PLANNING AND ZONING BOARD STAFF REPORT

109 SE 5th Avenue

Meeting	File No.	Application Type
April 21, 2025	2024-104	CBD Architectural Style
Applicant/Property Owner		Authorized Agent
109 5 th LLC		Neil Schiller, Esq.

Provide a recommendation to the City Commission regarding the implementation of the Contemporary Functionalism architectural style within the Central Business District (CBD), pursuant to LDR Section 4.4.13(F)(3)(c), Other Architectural Styles.

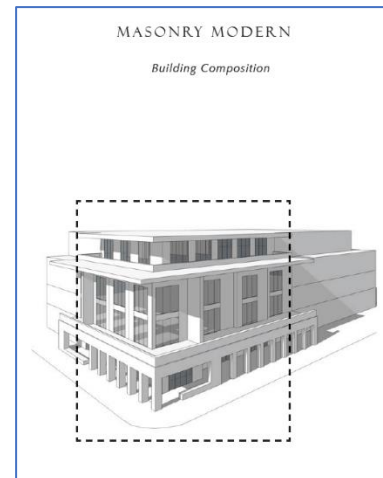
It is important to note that the seven styles are based on vernacular architecture that responds to Delray Beach's history and climate. Comparing the description of the proposed style to the current Masonry Modern category, the proposal appears to be consistent with some of the Masonry Modern characteristics, with a few critical differences: the use of expansive glass walls, rather than punched openings is a key departure from the masonry modern style, as well as the material and color palate which implements various non stucco treatments and colors that are darker than would be expected for the style. In comparison, Masonry Modern "Emphasizes the solidity of the structure" while the proposal has "use of expansive glass", which is inherently not an emphasis on the solidity of the structure.

The solidity of Masonry Modern is related to thicker walls historically utilized in warm climates to have cooler interior temperatures and references current concrete construction techniques. Aspects of design are derived from environmental context, which is why it is imperative that design styles introduced into the CBD have an established vernacular relevant to the geographic location and local context.

The applicant has provided four examples on pages 5 and 6 of their style narrative. However, it is important to note, three of the four examples, 2005 Calais Drive in Miami Beach, 4098 NE 167th Street in North Miami Beach and the building in Aventura appear fairly consistent with the Masonry Modern style in the CBD Guidelines, raising the question of whether the proposal meets the criteria of providing a "documented and substantiated Florida vernacular architecture" that is indeed separate and distinct from Masonry Modern and if the design should instead be adjusted to better conform to the established criteria for Masonry Modern.
